# UNITED STATES PATENT AND TRADEMARK OFFICE

APPLICATION NO.	FILING DATE	FIRST NAMED INVENTOR	ATTORNEY DOCKET NO.	CONFIRMATION NO.
10/033,113	10/25/2001	Allan Charles Acciaccia	DP-305859	7686

# Office Action Summary

### DETAILED ACTION

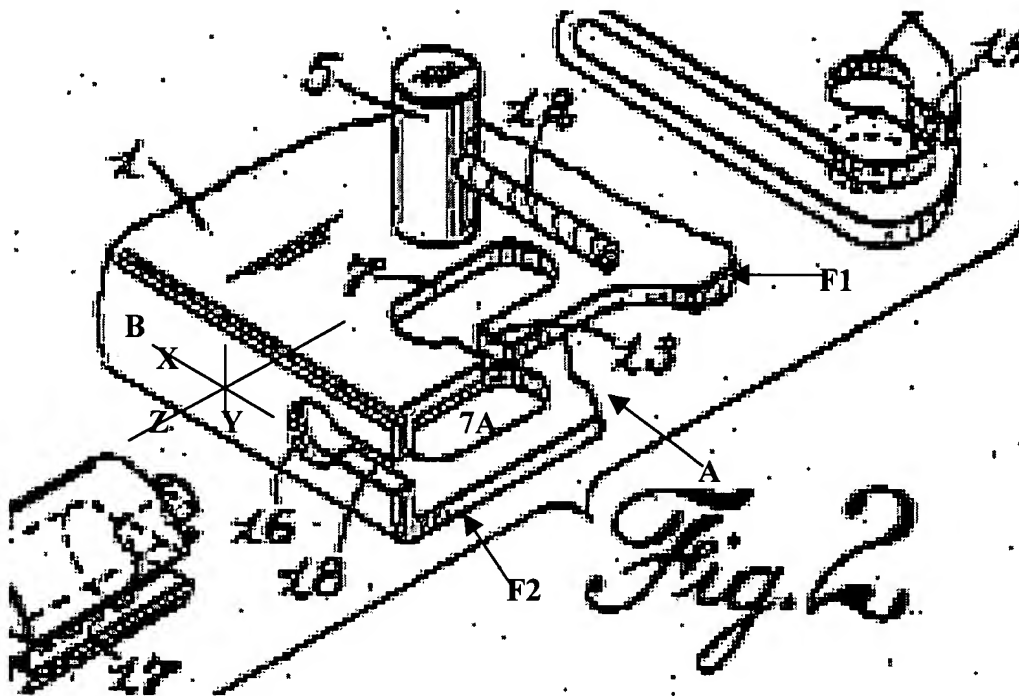
extending across the member **1** on opposite sides of the loading slot **A**, the loading slot **A** spanning the separate fingers **F1,F2** to form openings between the fingers **F1,F2** at opposite sides of the end portion, the end portion having a retaining slot **16,18** that is transverse to the loading slot **A**, the loading slot **A** having an inner end portion (near opposite side of surface **B**) and the retaining slot **16,18** having an outer end portion **18** that overlaps the inner end portion of the loading slot **A**, the end portion having a first transition slot **7** that extends from one of the opposite sides of the end portion through one of the fingers **F1** into the inner end portion of the loading slot **A** and the overlapping outer end portion **18** of the retaining slot **16,18**, the end portion having a second transition slot **7A** that extends from another of the opposite sides of the end portion through another of the fingers **F2** into the inner end portion of the loading slot **A** and the overlapping outer end portion **18** of the retaining slot **16,18**, and the cable **12** extending through the retaining slot **16,18** and having a ferrule **5** that engages a surface of the end portion adjacent the retaining slot **16,18** for moving the member **1**, the cable **12** being moveable axially in the retaining slot **16,18** to form a lost motion attachment with the end portion of the member **1** (see annotated figure 2 below; columns 1 and 2).

- b. More specifically, the Examiner has read the Gleasman reference such that any "slot" shown therein extends indefinitely in a direction transverse to a defined planar boundary of a given slot. For example (see figure 2 as modified below), with respect to the retaining slot **16,18**, the Examiner understands this slot to extend in two directions (X,Y) in the plane of surface **B** as well as indefinitely in a direction (Z) transverse to the plane of surface **B** such that the slot can be said to "overlap" with an inner end portion of space **A** between the plates **F1,F2**. In the same respect, slots **7** and **7A** are interpreted to extend in two directions (Z,X) along the surfaces of plates **F1 and F2** as well as indefinitely in a direction (Y) transverse to the surfaces of plates **F1 and F2** such that the slots **7 and 7A** can be said to "overlap" with one another as well as with retaining slot **16,18** and space **A**. In essence, each "slot" has boundaries defined in one plane but is understood to extend indefinitely in directions transverse to that plane. The Examiner respectfully asserts that such an interpretation of Gleasman overcomes Applicant's arguments as to the subject matter recited in paragraphs b-d of claim 1 as denoted in pages 8-9 of the response (paper no. 6).

c. Next, Applicant argues that the Gleasman ferrule **5** does not engage a surface of the end portion adjacent the retaining slot for moving the member. The Examiner disagrees. Specifically, the ferrule **5** engages a surface of the slot **7 and 7A**. In view of the understanding of Gleasman expressed above, the Examiner respectfully submits that the surfaces of slots **7 or 7A** can indeed be considered adjacent to the retaining slot **16,18**, since this slot is understood to “overlap” with slots **7 and 7A**. The term “adjacent” is not deemed to distinguish over the structure disclosed in Gleasman.

- e. Regarding claim 3, Applicant argues that slots **7 and 7A** are not coplanar. The modified version of figure 2 above shows, however, that slots **7 and 7A** both lie in the (Y,X) and (Y,Z) planes. Thus, this argument is not persuasive.

- f. Regarding claim 4, Applicant argues that slot **16,18** is not linear as recited in the claim. This is not persuasive. Portions **16 and 18** of the slot lie in a straight line and, thus, the slot is linear. This meets the claimed limitation. The claim does not recite that the walls of the slot are flat or linear, which is what Applicant seems to be implying. The shape of portion **16** is irrelevant in view of the claim as written.

- h. Regarding claim 8, Applicant argues that the retaining slot **16,18** is not perpendicular to loading slot **A**. In view of the understanding of Gleasman expressed above, the Examiner maintains that slot **16,18** can be considered perpendicular to slot **A**. Specifically, slot **16,18** extending in the Z direction is perpendicular to slot **A** which extends, for example, in the X direction. Thus, this argument is not persuasive.
